ADDENDUM NO. 2

PROJECT TITLE:
REPLACEMENT OF BRIDGE NO. 06896, ROUTE 156 OVER ARMSTRONG BROOK

TOWN:
OLD LYME
 DRAWING TITLE:
GENERAL PLAN AND NOTES

TOWN:
OLD LYME
DRAWING TITLE:
ELEVATIONS AND LONGITUDINAL SECTION

SCALE: 1/4" = 1'-0"

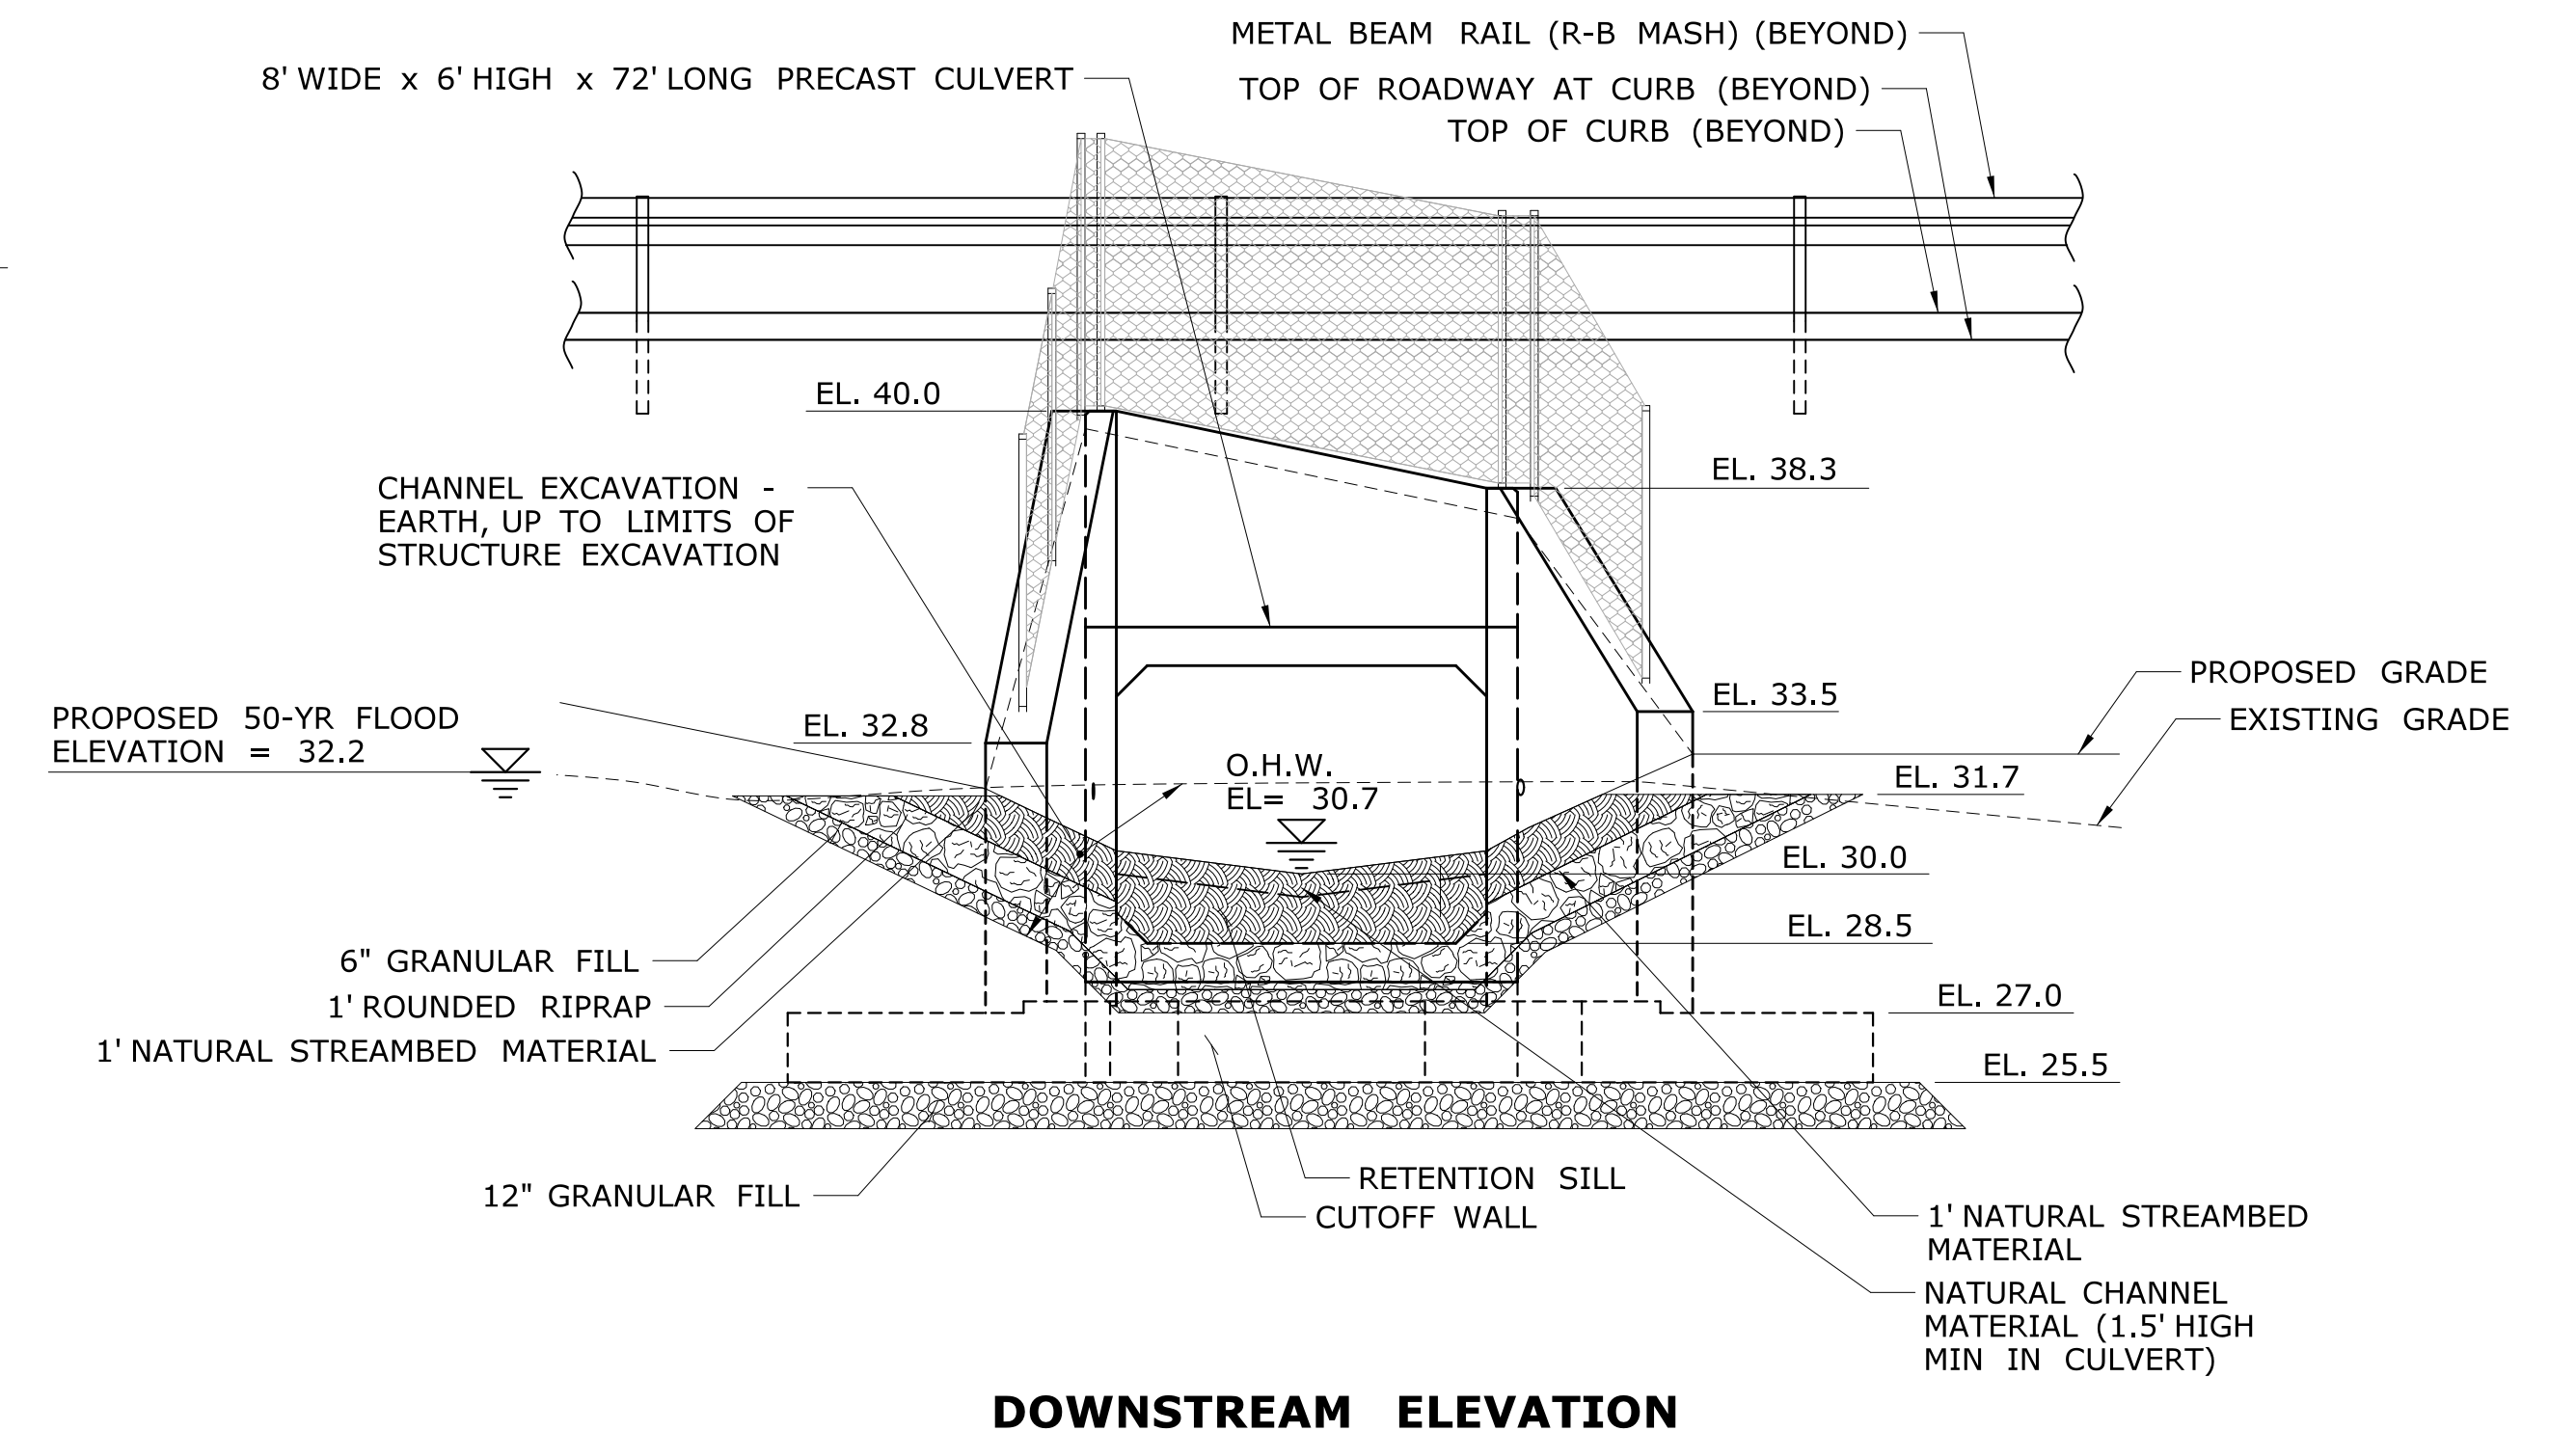
REV.	DATE	REVISION DESCRIPTION	SHEET NO.
1	1.31.25	ADD SANITARY FORCE MAIN	04.03

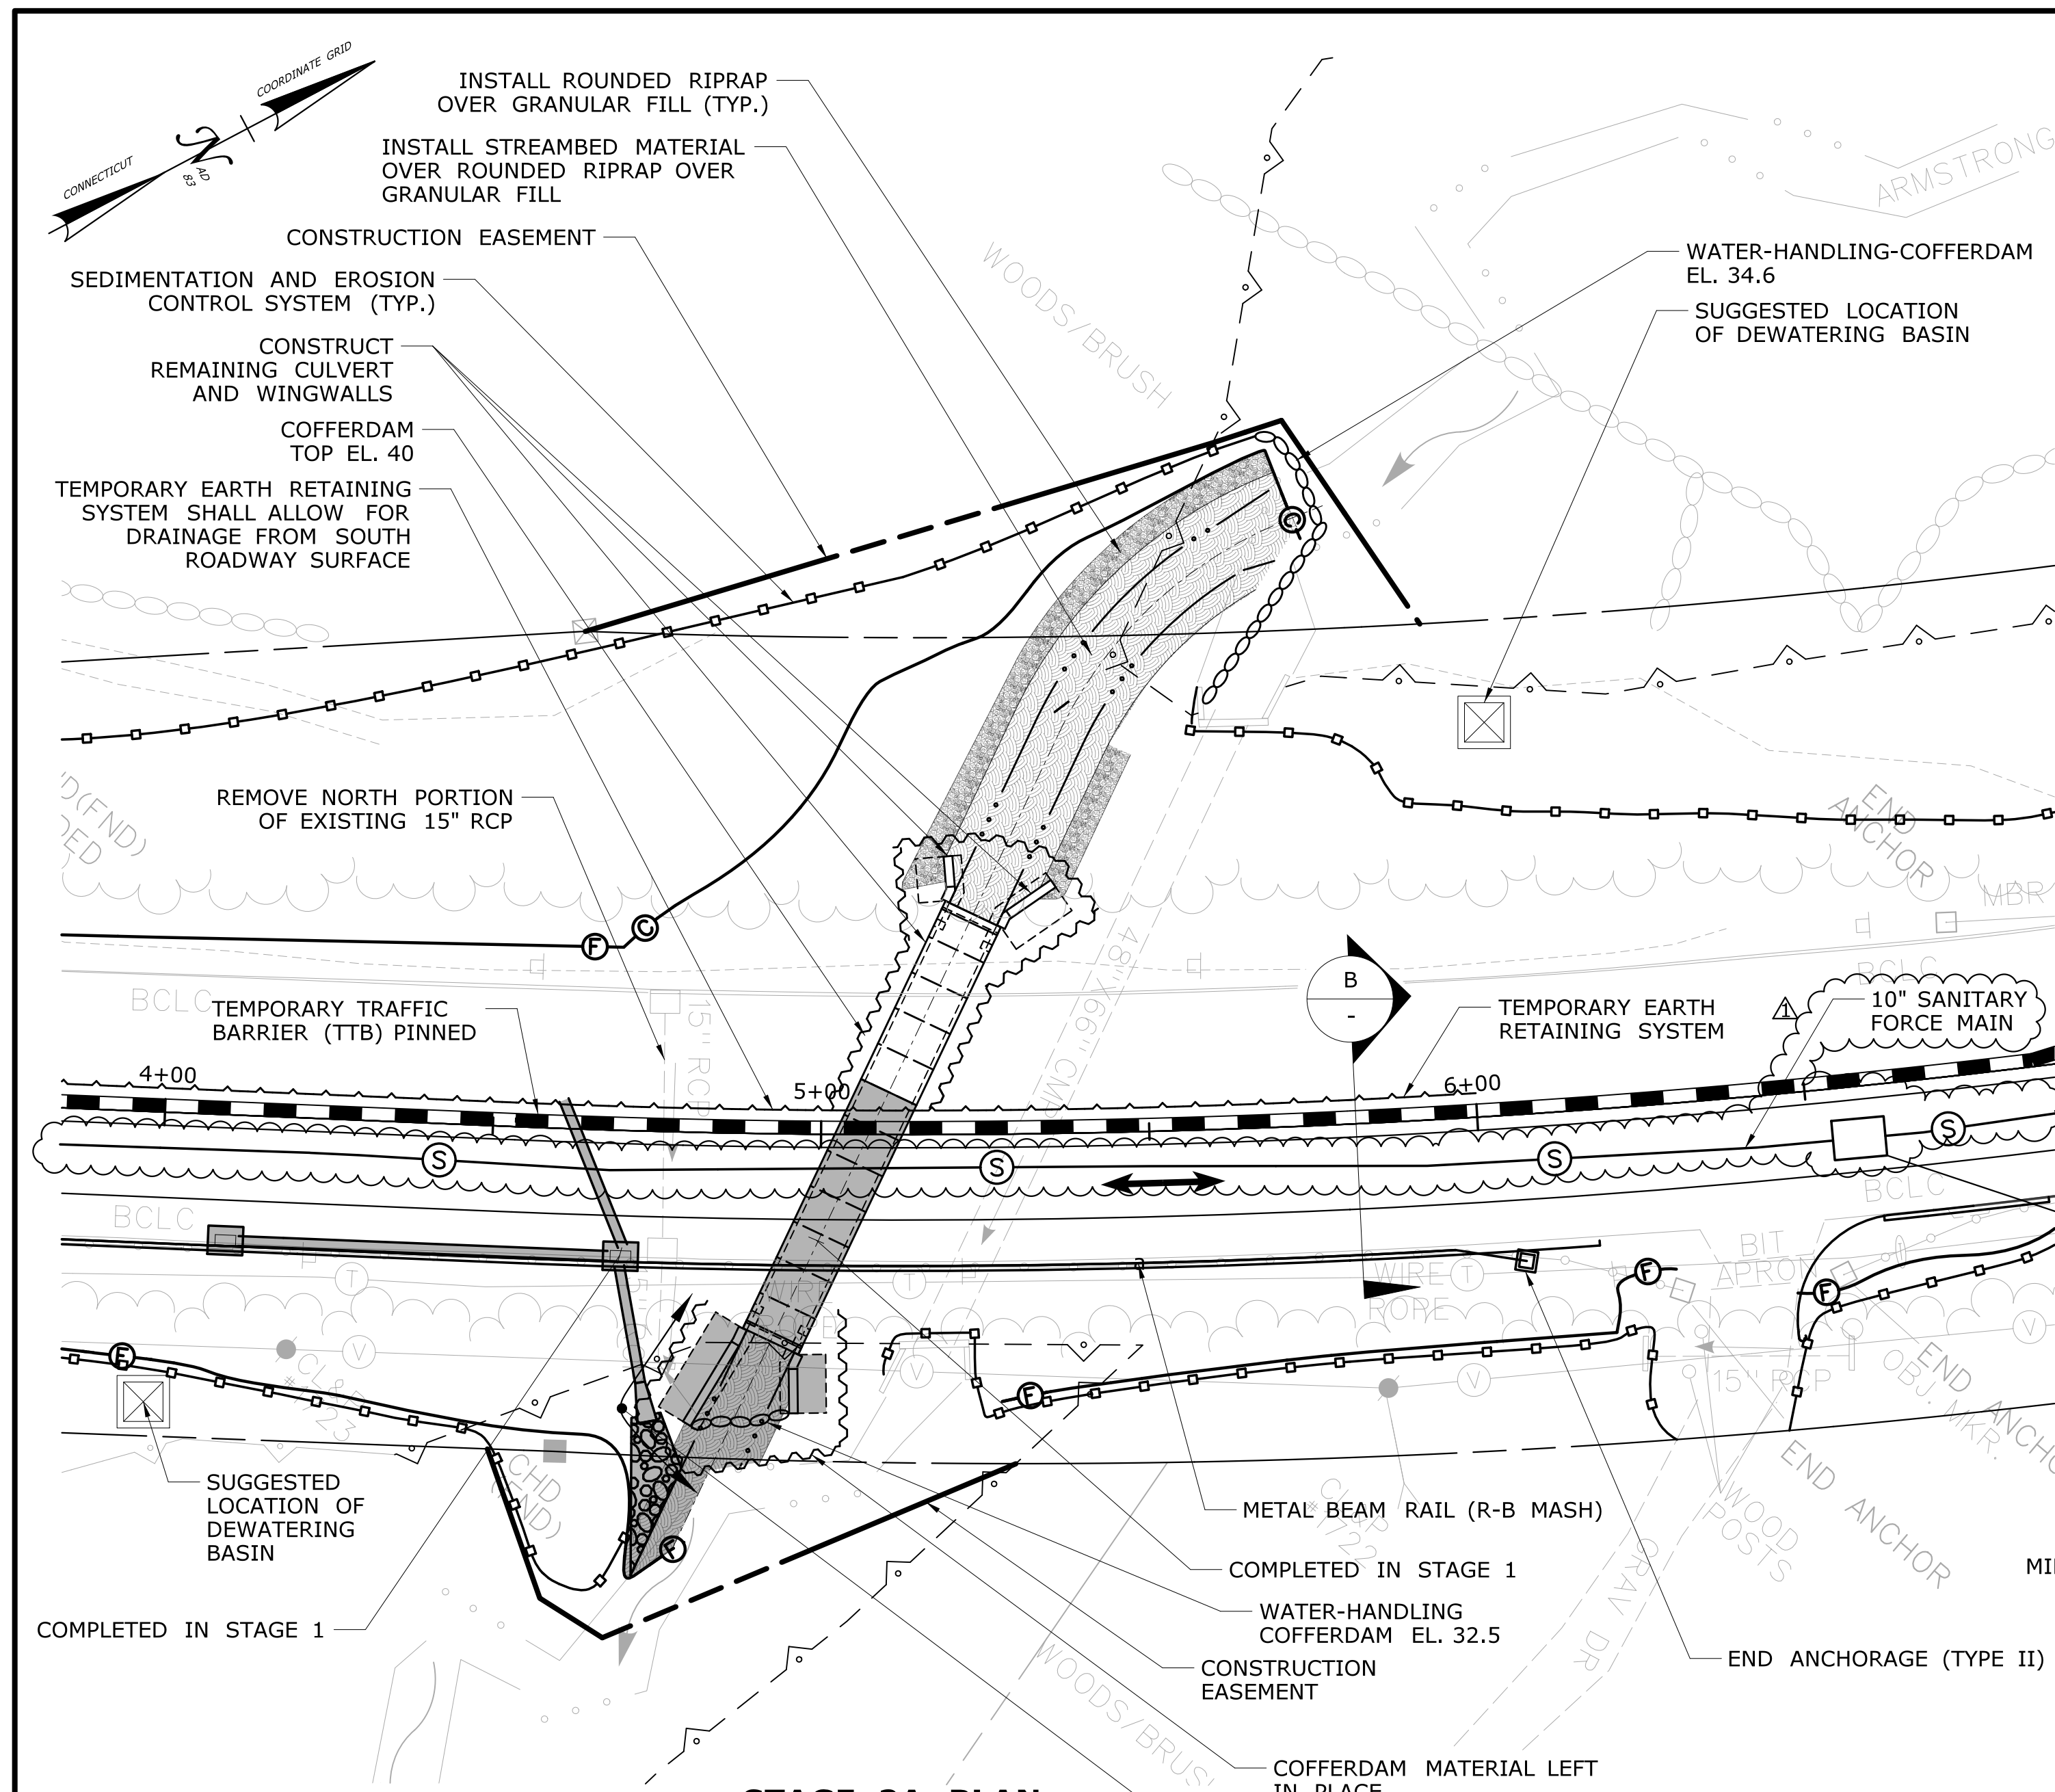
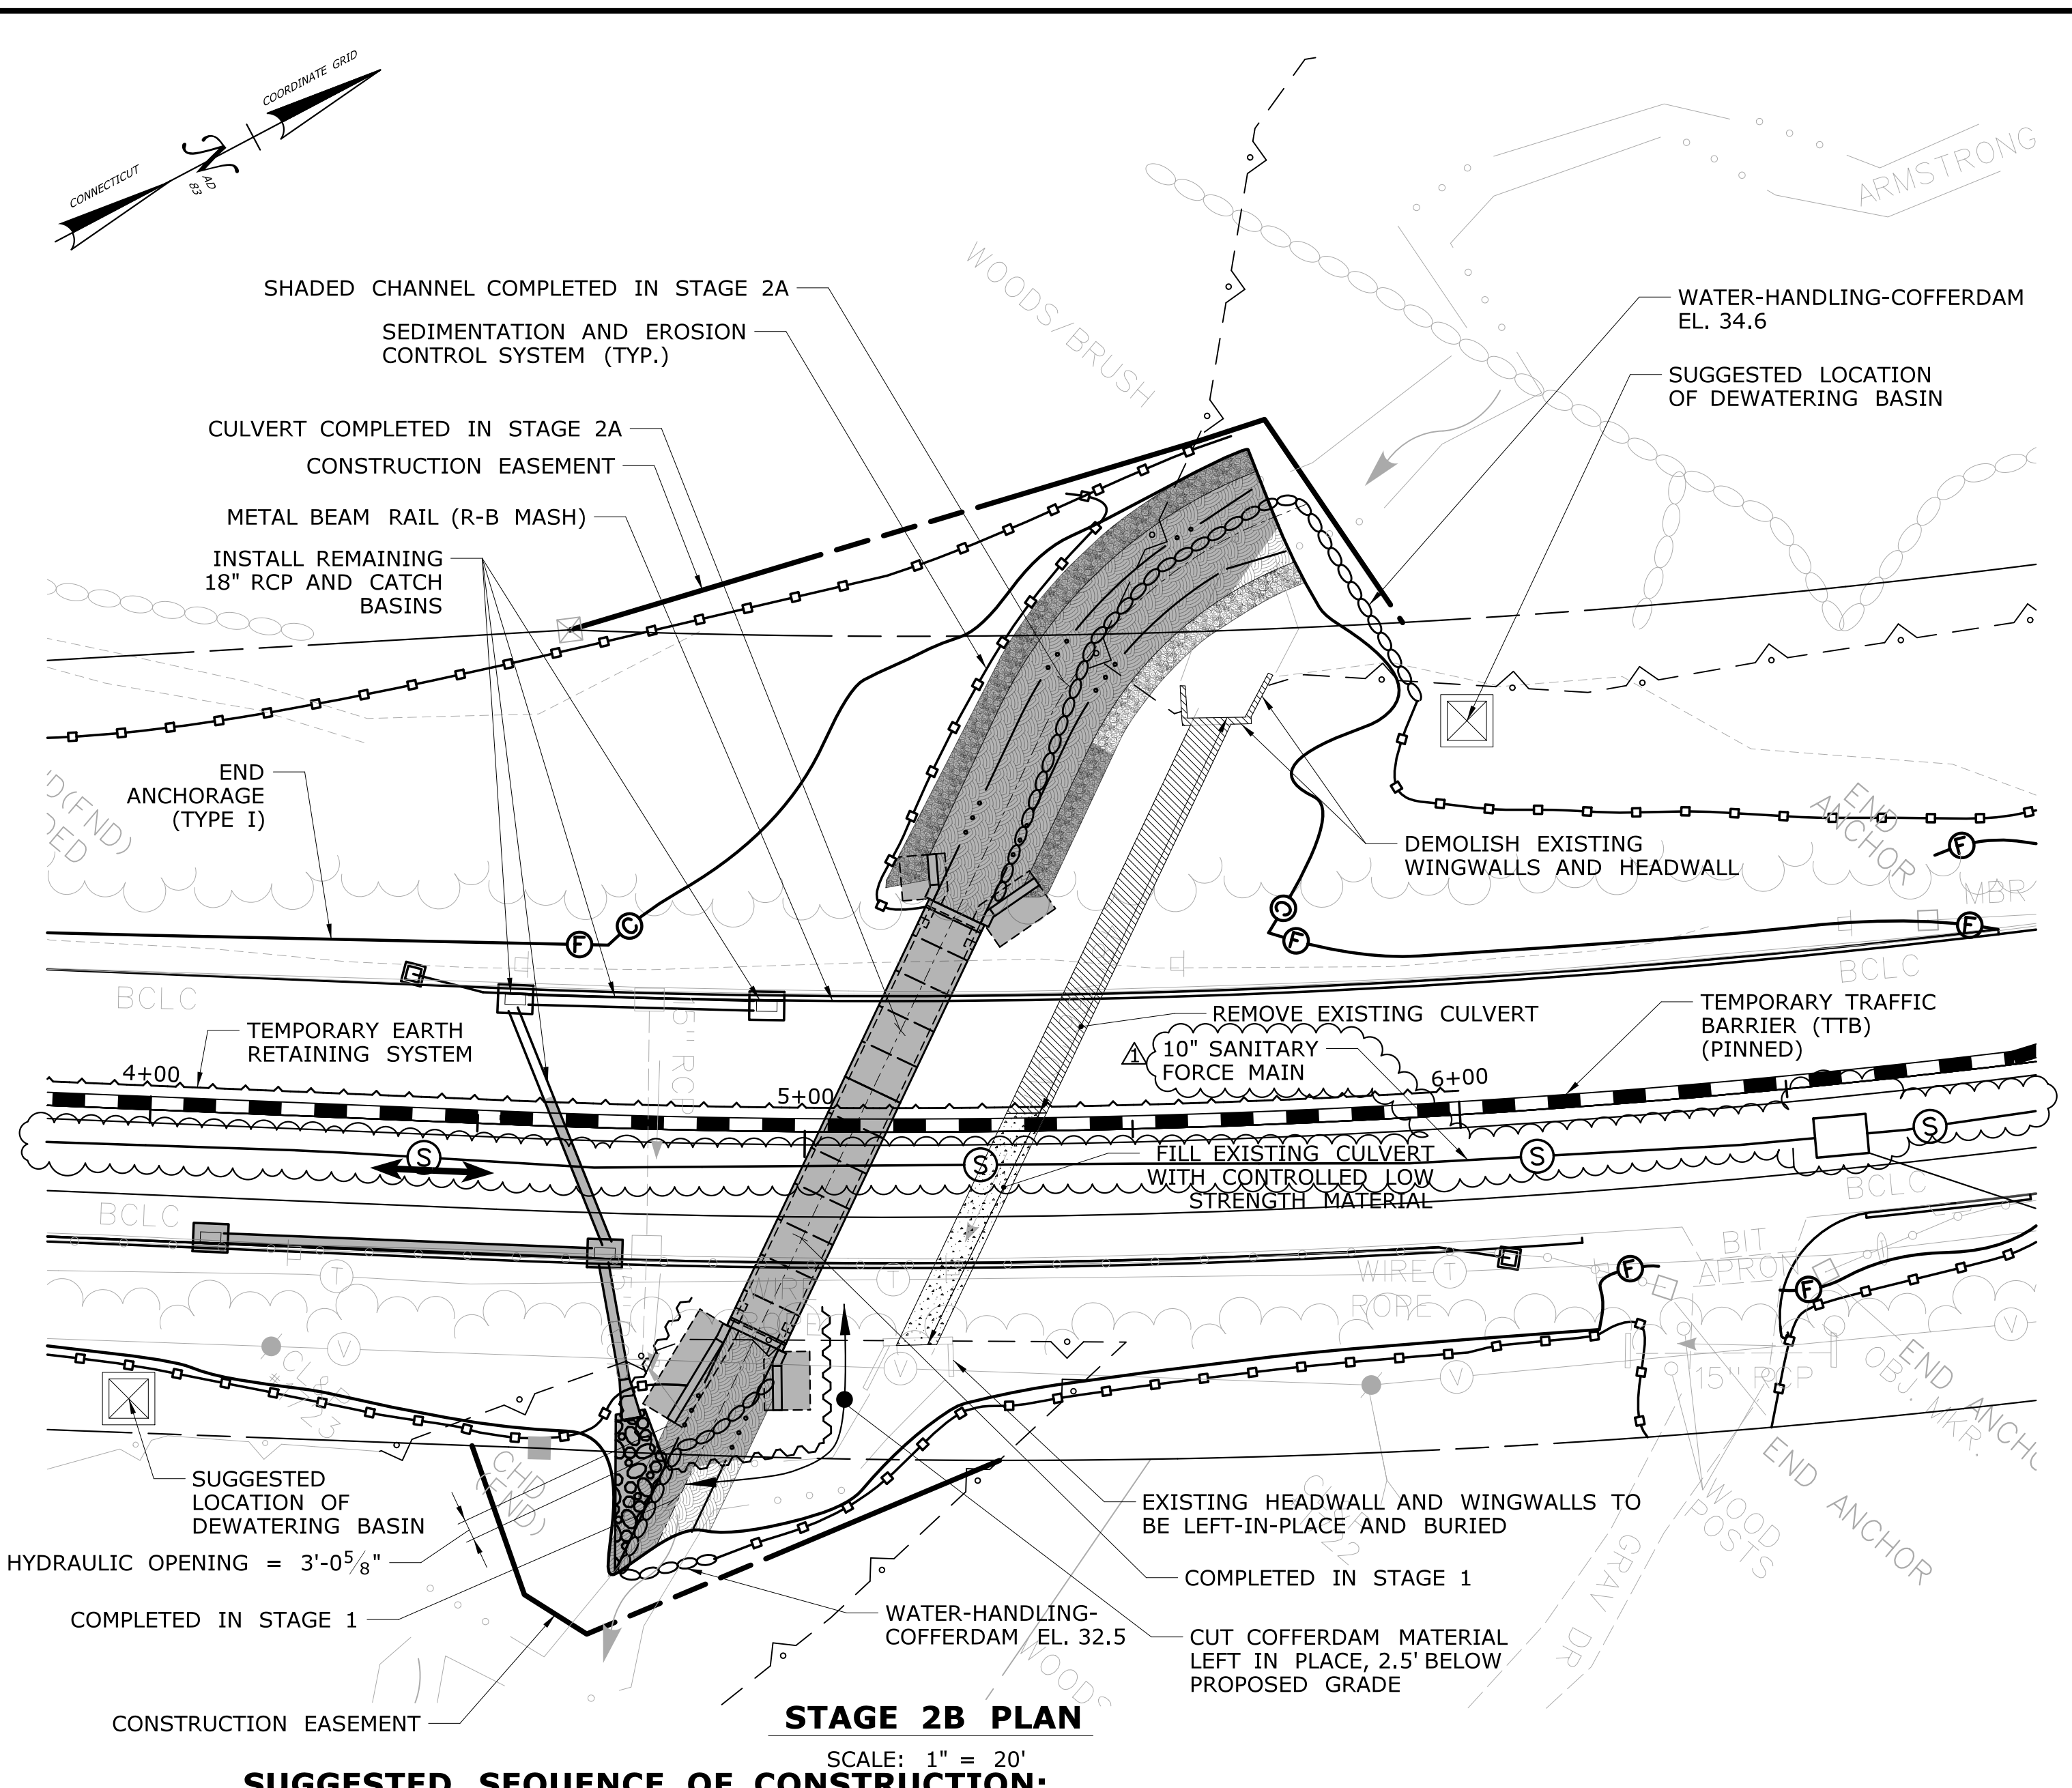
1.31.25 REV. DATE	ADD SANITARY FORCE MAIN REVISION DESCRIPTION	04.06 SHEET NO.	THE INFORMATION, INCLUDING ESTIMATED QUANTITIES OF WORK SHOWN ON THESE SHEETS IS BASED ON LIMITED INVESTIGATIONS BY THE STATE AND IS IN NO WAY WARRANTED TO INDICATE THE CONDITIONS OF ACTUAL QUANTITIES OF WORK WHICH WILL BE REQUIRED.	DESIGNER/DRAFTER: N. ROSSI CHECKED BY: S. NALITZ SCALE AS NOTED	STATE OF CONNECTICUT DEPARTMENT OF TRANSPORTATION PRIME AE	SIGNATURE/ BLOCK: 	PROJECT TITLE: REPLACEMENT OF BRIDGE NO. 06896, ROUTE 156 OVER ARMSTRONG BROOK	TOWN: OLD LYME	PROJECT NO. 104-175 DRAWING NO. S-06 SHEET NO. 04.06.A2
----------------------	---	--------------------	--	---	--	--------------------------	--	--------------------------	---

13. EXCAVATE AND CONSTRUCT SOUTH HALF OF PROPOSED BOX CULVERT, HEADWALL B, WINGWALLS 1B & 2B AND BACKFILL.
 14. INSTALL 10" SANITARY FORCE MAIN.
 15. PARTIALLY REMOVE COFFERDAM. SEE STAGE 2A FOR LIMITS OF COFFERDAM MATERIAL LEFT IN PLACE.
